VSP-33  
December 18, 1981

VENDOR SERVICE PUBLICATION

To: All Piper Distributors and CORPAC's  
Subject: Bendix Service Bulletins 611, 616, 617, 619

**Figure 1. Location of Drain Holes**

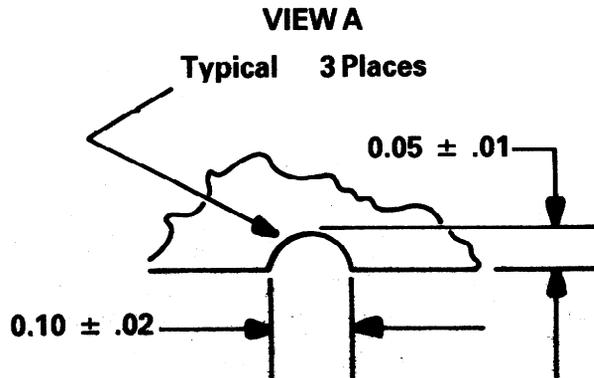
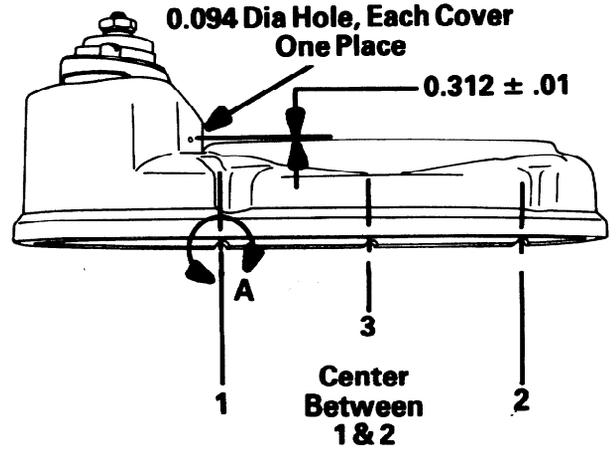
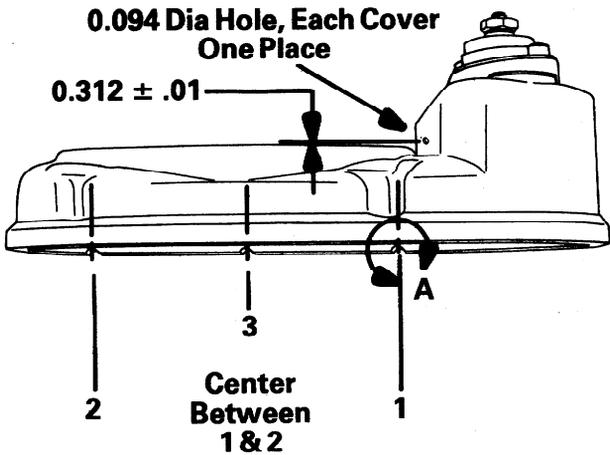
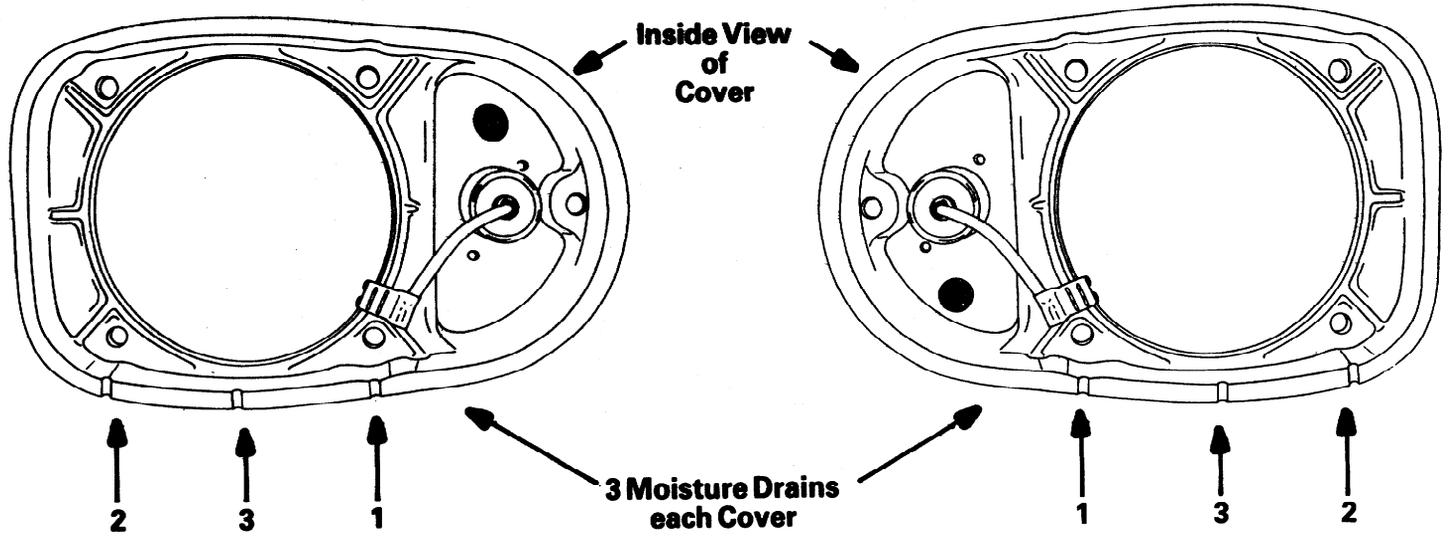
Series Magnetos. This moisture contamination may cause ignition difficulties, resulting in possible engine roughness. The addition of moisture drains and sealing of the screen vent in the magneto cover will provide a means for drainage of accumulated moisture and prevent moisture from entering the magneto through the screen vent.

1. Remove the magneto cover by removing the ignition harness adapter plate from each magneto and then removing the magneto cover securing screw. Pull the magneto cover away from the magneto and carefully pull the capacitor, and retard lead, if used, from the breaker flag terminal(s).
2. Using Figure 1 as a guide, lay out the positions for the moisture drains. Positions 1 and 2 are in line with the stud holes in the cover and position 3 is centered between 1 and 2. Using a small round file, create the three hemispherical recesses as detailed in view A, figure 1.

The moisture drains must be on the lower side of each cover when it is reinstalled on its related magneto assembly on the engine.

3. Lay out the position for drilling a 0.094 in.  $\pm$  0.005 in. hole in the center of the ledge area of the covers and drill one hole in each cover using a 3/32" or No. 42 drill, as shown in Figure 1.

Do not allow the drill to penetrate through the cover and hit the housing of the capacitor which is directly in line with the hole being drilled. Mask drill bit for maximum allowable depth (1/4 in.).

4. Remove any burrs left during the filing and drilling operations on the covers and clean the covers of any metal shavings. Apply a thin coat of black enamel to the bare metal exposed during the filing of the moisture drains. Avoid getting paint on the adjacent cover-to-magneto mounting surface.

5. With a putty knife, spatula or similar tool, apply a sufficient amount of sealant to the outside of the vent screen to fill the vent screen recess flush with the adjacent cover surface. Acceptable sealants are listed below:
  - a. Dow Corning Sealant No. 3145
  - b. Permatex No. 1
  - c. Hi-Sol Epoxy Patch, Kit 1C
  - d. G.E. Silicone Sealant (Automotive type)

Figure 1. Exploded View

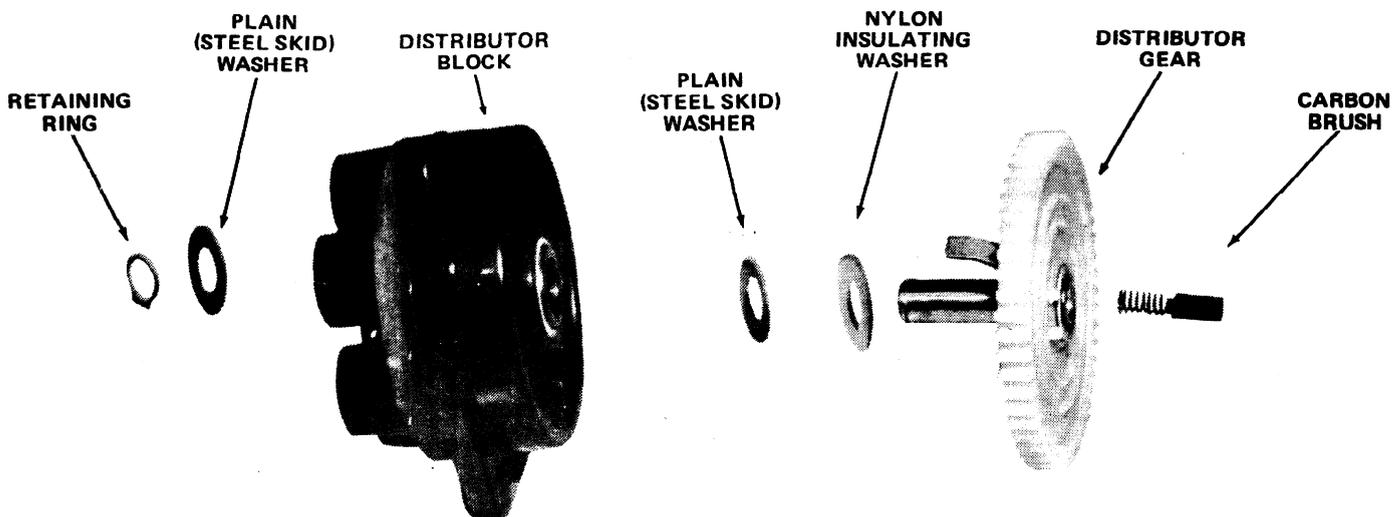
The 10-357584 and 10-357586 Insulated Distributor Gear Kits for S-20 and S-200 Series Magnetos are being provided as a standardization change for Bendix magnetos. With the introduction of these kits, all new Bendix aircraft magnetos delivered from the factory will be provided with insulated distributor gears. The insulated gear kits include all parts (except distributor block) as identified in figure 1.

The 10-357584 gear kit for four cylinder magnetos will replace the 10-50746Y distributor gear, and the 10-357586 gear kit for six cylinder magnetos will replace the 10-157197 distributor gear when current

Assembly sequence of the gear kit to distributor block is shown in the exploded view of figure 1.

Figure 1. Location of "x" on Identification Plate

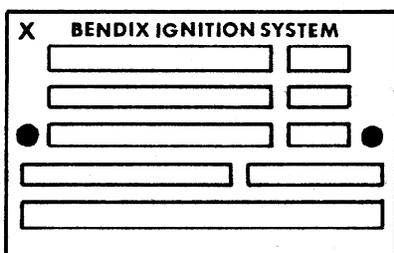
All D-2000/2200 series magnetos below serial number 35480 (red label magnetos) and below serial number 8122106 (blue label magnetos) unless identified with an "x" in the upper left corner of the identification plate before the word "Bendix" (see figure 1). The "x" on the identification plate indicates previous compliance.

6. If new serviceable gears, identified with the "z", the "x" and "o", or the "L" are installed in the magneto, identify the magneto by stamping the letter "x" in the upper left corner of the identification plate, before the word "Bendix" (see figure 1).

Figure 2. Location of Identification Mark(s)  
on Distributor Gear

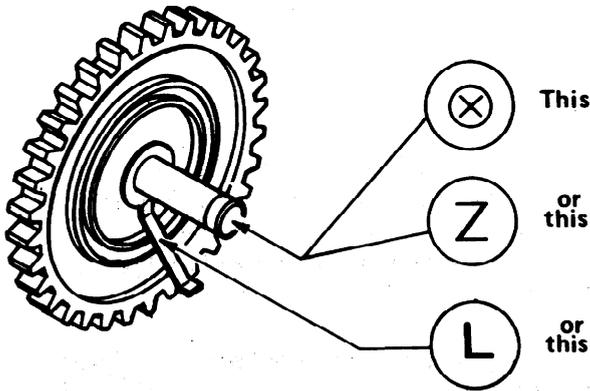
hours or at the next regularly scheduled inspection, whichever occurs first, and reinspected every 100 operating hours until the magneto has 500 operating hours. If the gears fail the inspection they must be replaced immediately with new, serviceable gears; if they pass each inspection they may remain in service until magneto overhaul, at which time they must be replaced with new, serviceable gears. At owner's option, gears that pass inspection may be replaced at any time during the compliance period with new, serviceable gears as identified in this paragraph and figure 2. Serviceable gears are identified by the presence of the letter "z" or the letters "x" and "o" appearing together, laser etched on the retaining ring end of the gear axle, or the letter "L" stamped on the electrode (see figure 2).

1. Remove cover from magneto and inspect the retaining ring end of the distributor gear axles for the letter "z" or the letters "x" and "o". (The letter "x" may or may not be circled by the letter "o".) If the letter "z" or the letters "x" and "o" together are laser etched on the end of the axles, the gears are serviceable and the cover can be reinstalled. Identify the magneto per

3. Inspect the block for serviceability and replace any block found to be unserviceable.
4. Clean and inspect each gear. If the gear is part of an insulated gear kit (identifiable by the presence of a nylon insulating washer on the gear axle between the gear and the block) inspect for the presence of the letter "L" on the electrode (see figure 2). If "L" is stamped on the electrode, the gear is serviceable and can be reinstalled. If "L" is not present, the gear must be replaced with serviceable gear, P/N 10-682014 for 4 or 8 cylinder magnetos or P/N 10-682016 for 6 cylinder magnetos.

Figure 1. Location of "x" on Identification Plate

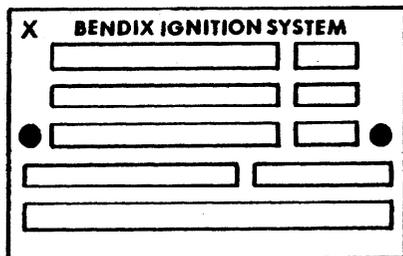
All D-3000/3200 Series (blue) Magnetos with Serial Numbers 100 through 1968 not identified by the letter "x" in the upper left corner of the identification plate (see figure 1). The "x" on the identification plate indicates previous compliance.

7. After the magneto has been reassembled with new serviceable gears, identify the magneto by stamping the letter "x" in the upper left corner of the identification plate, before the word "Bendix" (see figure 1).

Figure 2. Location of Identification Mark(s) on Distributor Gear

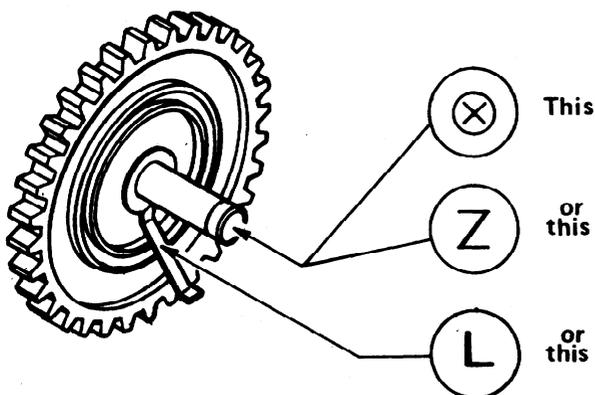
All distributor gear kits P/N 10-682014 and P/N 10-682016 which contain gears that are not identified by the presence of the letter "z" or the letters "x" and "o" together, laser etched on the retaining ring end of the gear axle, or the letter "L" stamped on the electrode (see figure 2).

5. Reassemble the distributor block with new serviceable gears. Serviceable gears are identified by the presence of the letter "z" or the letters "x" and "o" together, laser etched on the retaining ring end of the gear axle, or the letter "L" stamped on the electrode (see figure 2).
